PLES I GEOTHERMAL DEVELOPMENT PROJECT

FINAL ENVIRONMENTAL IMPACT STATEMENT AND SUPPLEMENTAL ENVIRONMENTAL IMPACT REPORT

June 1989

FIGURE: 3-5
Habitat Type Map

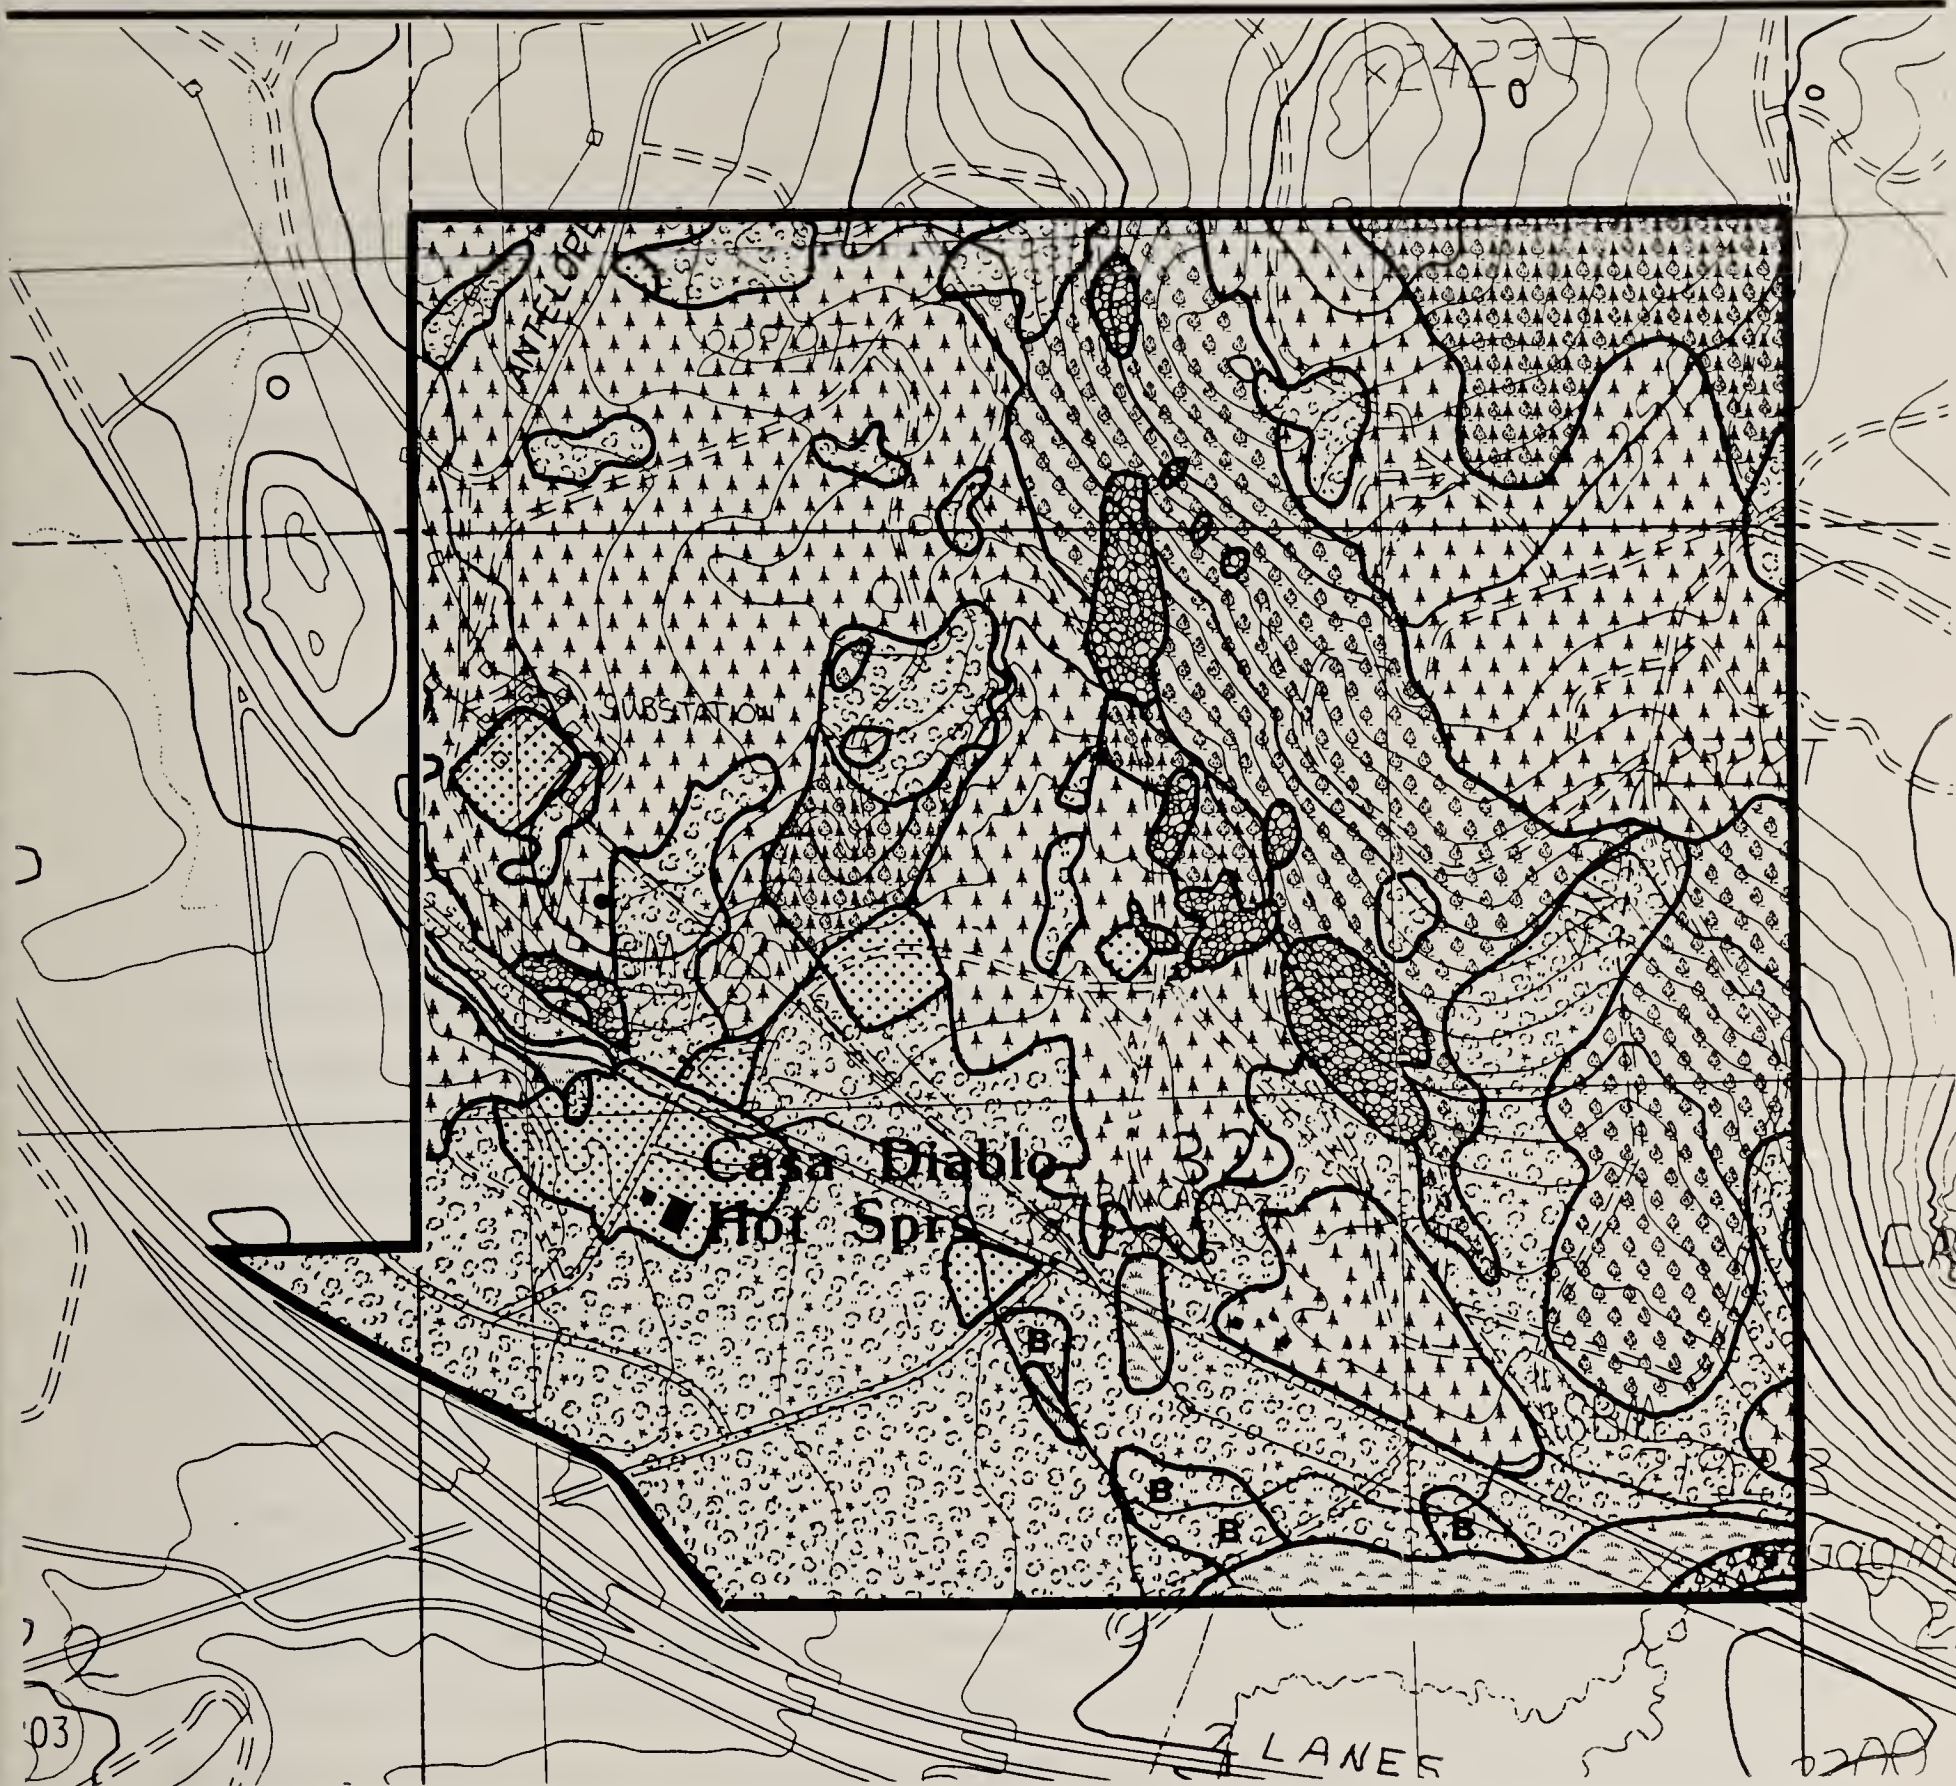
6-15 Page 3-36 Figure 3-5 Here is another example of the lack of detail in the DEIS for the "alternative site location". Why doesn't this map cover the areas occupied by all alternatives?

- 10-6 6. Page 3-36, Figure 3-5. This map should be extended to the west to cover the lands which could be affected by the alternate plant location.
- 10-7 7. Page 4-34, section 4.1.4.2.1 Proposed Project Impacts. If the cold water well lowers local groundwater levels, would that have an impact on the ephemeral ponds to the west? If so, how could that be mitigated? This question should be addressed in the final EIS.

Response: Figure 3-5 includes the alternative power plant site and pipeline routes. It does not show the ephemeral ponds to the west for which detailed surveys have not been conducted. However, as the EIS/SEIR states, the ponds would be protected and their biological resources not impacted by the power plant at the alternative location through the mitigation measures.

FIGURE 4-1
 Cross-Section Along Line-of-Sight from
 Highway 395 Near Mammoth Creek to
 Proposed Power Plant Site

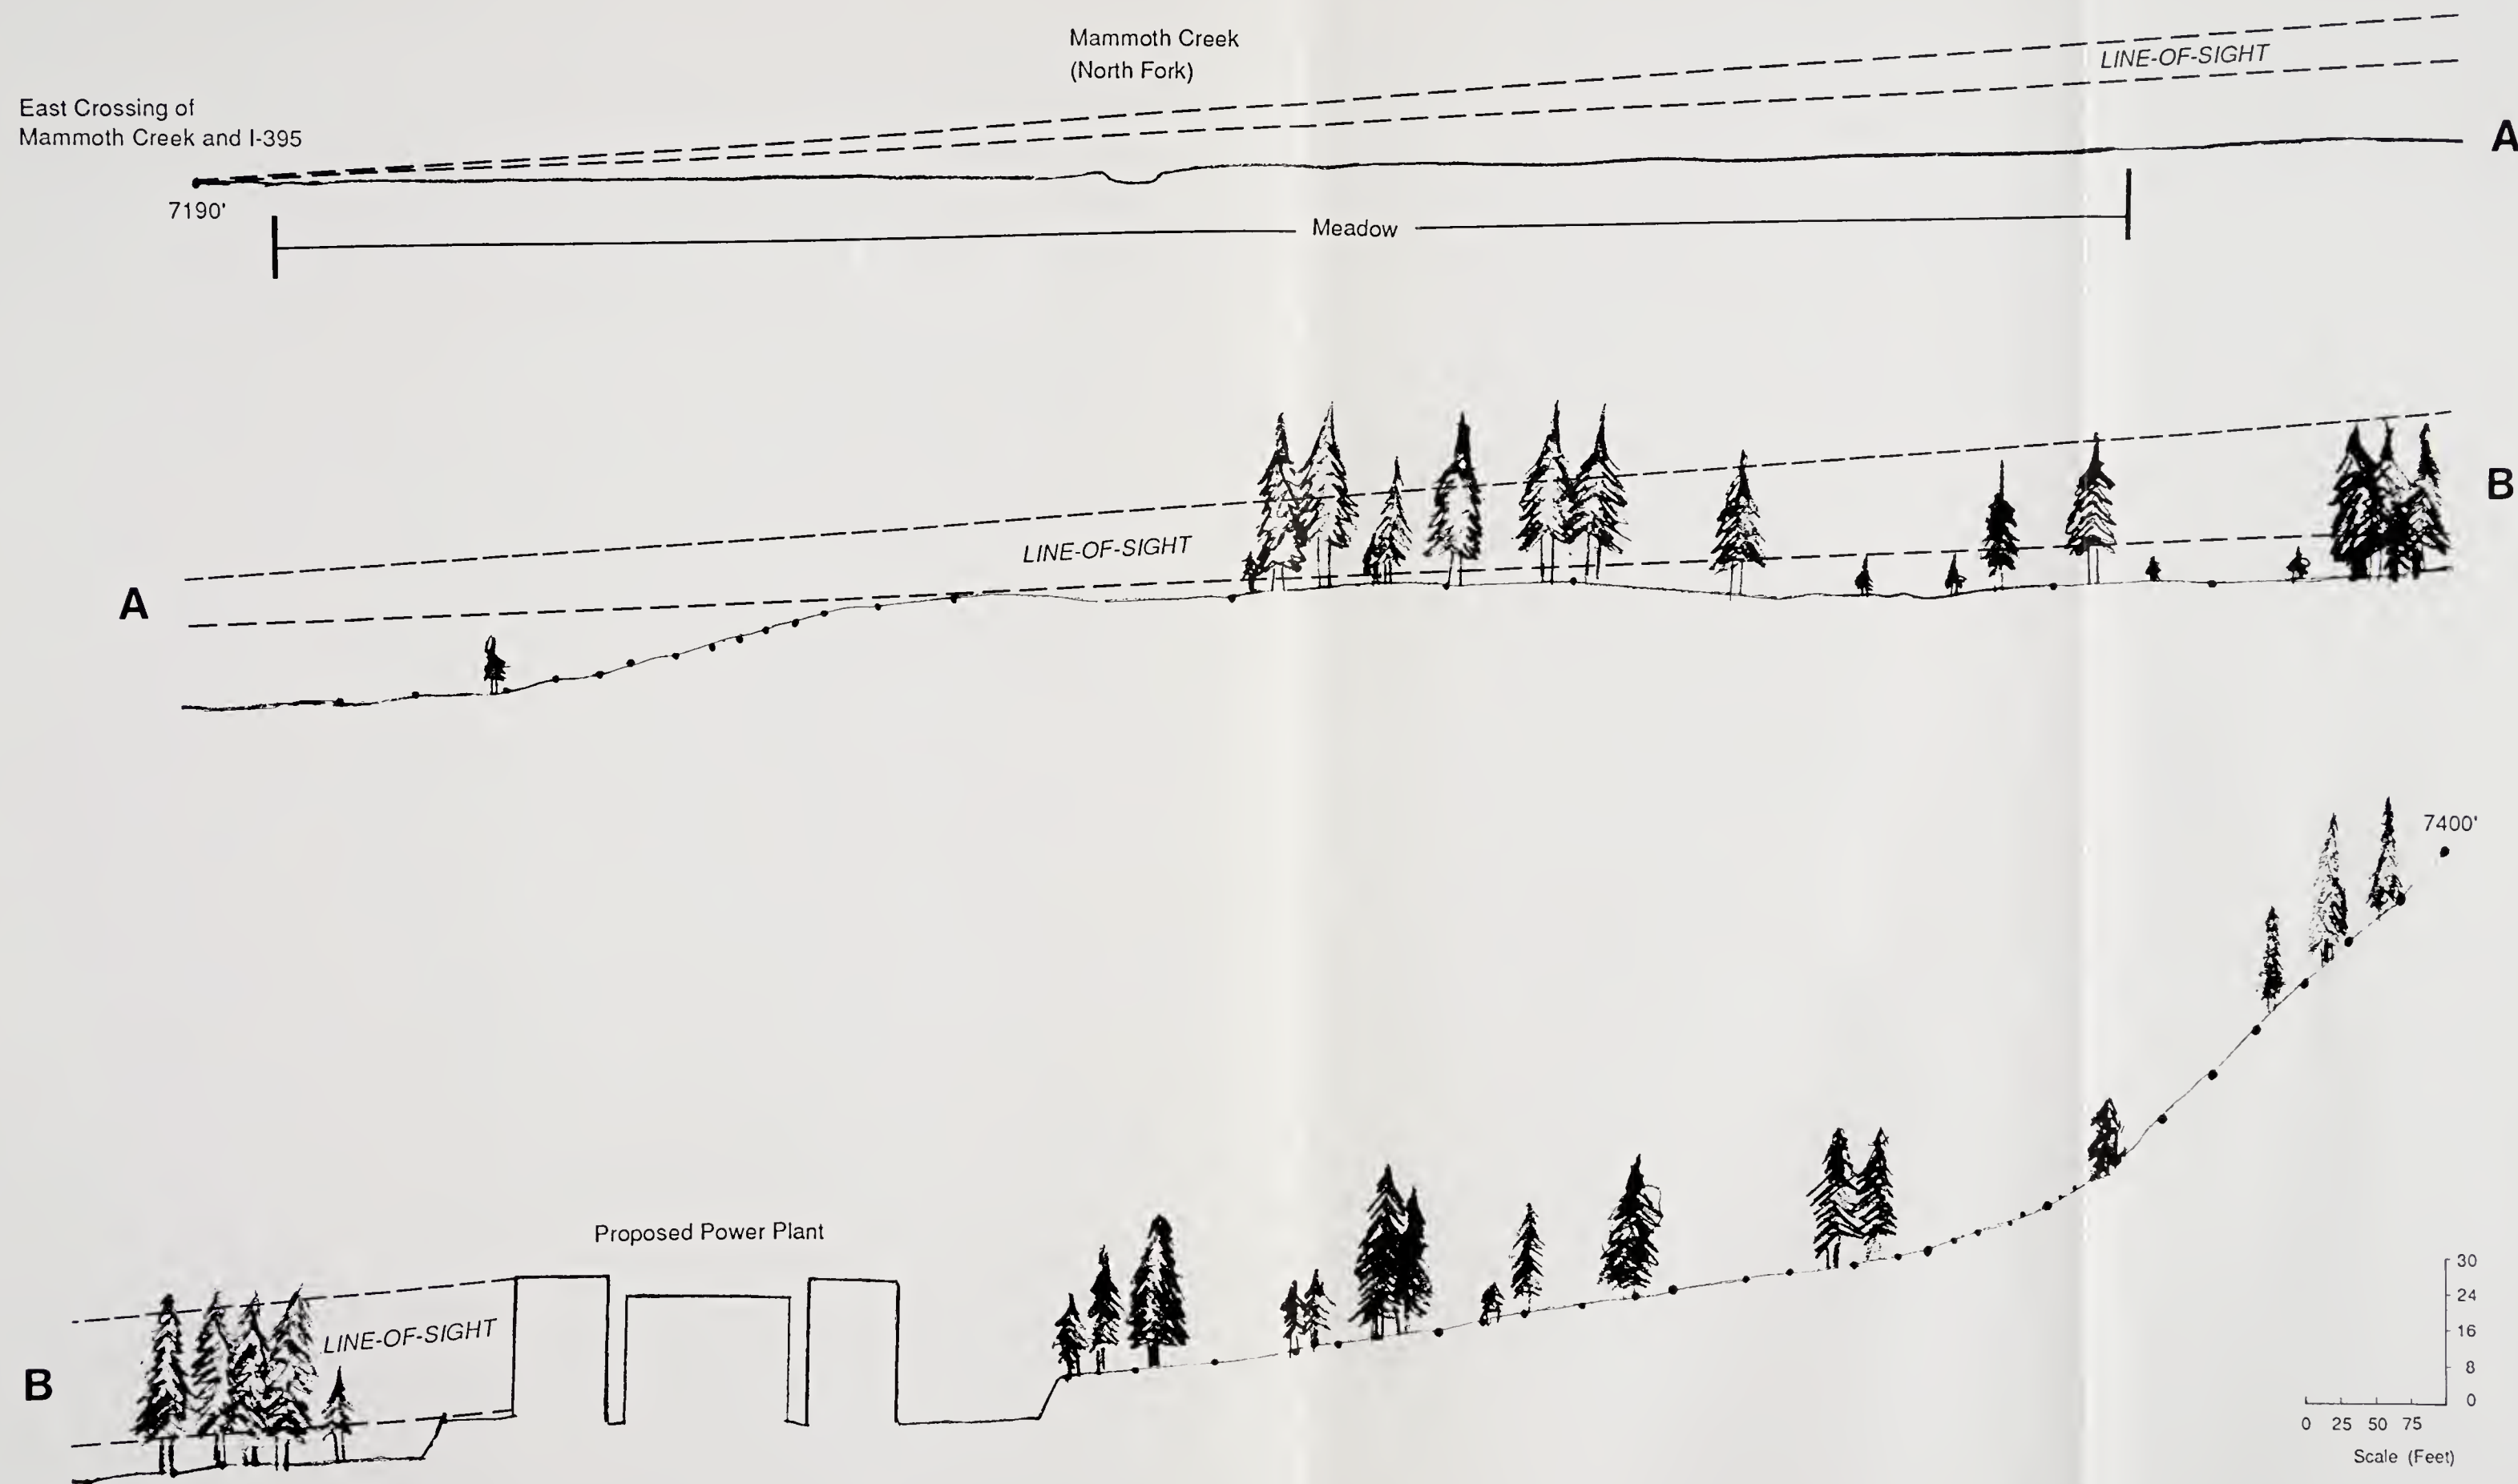
The extent of the visual analysis seems to be based on the assumption that viewers will be wearing blinders. The Sensitive vantage point used to generate Figure 4-1 is just that, a single point. Not only is it a single point, but it is also the lowest point along Hwy. 395 from which to view the project site. As a result, the impression given in figure 4-1 is very misleading. For instance, the overpass of Hwy. 395 at the intersection of Hwy 203 offers a much more exposed vantage point. In addition, people engaged in recreational activities on foot on the thousands of acres of surrounding forest service lands will have an unobstructed view of the project site. (see our scoping comments page 12)
